REGENERATION, SPORTS AND RECREATION DIRECTORATE REPORT IN ACCORDANCE WITH SECTION 38 OF THE ROAD TRAFFIC ACT, 1994, AS AMENDED BY SECTION 46 OF THE PUBLIC TRANSPORTATION REGULATION ACT 2009

Re: SOUTHSIDE CONNECTIVITY PROJECT

PROJECT:
SOUTHSIDE CONNECTIVITY

Figure 1. Map showing the primary secondary and Tertiary(feeder) routes in the LSMATS cycle network

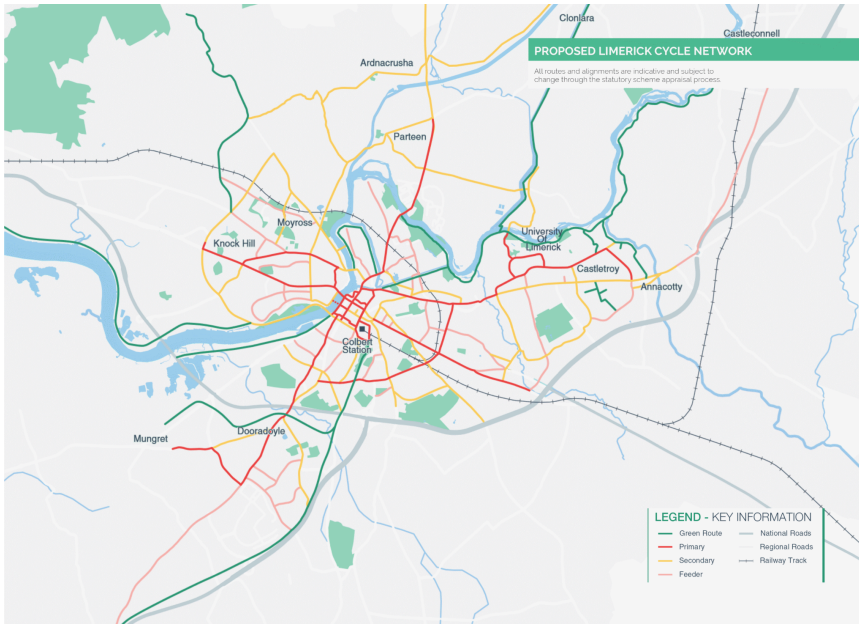
Limerick Cycling Campaign believes that the cycle network should be developed in a planned and strategic manner as per the Limerick Shannon Metropolitan Area Transport Strategy. i.e. primary network first, secondary network second and tertiary (feeder routes) third.

The primary network should be prioritised by starting with the city centre where density is highest and where the cycle network will receive the highest usage in line with meeting modal share targets.

This scheme does not provide any additional primary/secondary routes.

LSMATS identifies Childers Road as part of the Primary Cycle Network and the Synge Drive/Rathbane Terrace/Deer Court link as a feeder cycle route. While it is acknowledged that recent Active Travel works have been undertaken on the northern side of Childers Road, the aim for improved accessibility for pedestrians and cyclists on busy routes should be for such infrastructure on both sides of the carriageway. In addition, active travel infrastructure on the R511 south of Roxboro Roundabout, which LSMATS highlights as a secondary route, will follow as part of a subsequent planning application.

Figure 2. Extract from cycle propensity modelling showing a need for cycle infrastructure on the R511 towards southhill but no cycle demand for infrastructure on the R509.

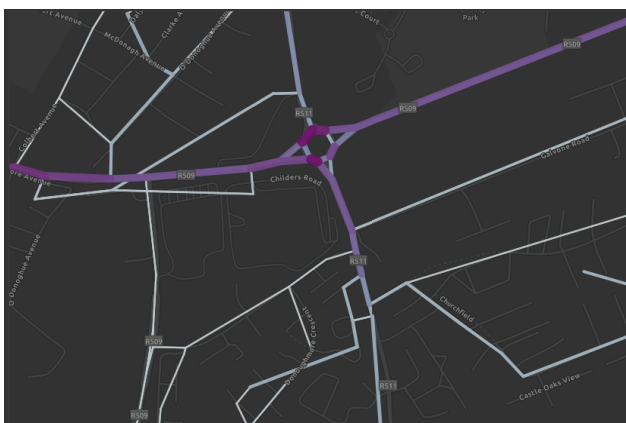
The approach within LSMATS is backed by the NTA regional transport modelling, planning and investment cycle propensity scenarios. It is not clear why Limerick City and County Council are ignoring this evidence by prioritising a scheme which will have negligible benefit for cycling modal share while also draining the budget which could progress schemes which would have a transformational impact.

This project in its current state would only serve two additional sections of road that NTA models indicate would have minimal influence. While the most significant route in this area, R511 south of Roxboro Roundabout which LSMATS highlights as a secondary route remains unserved.
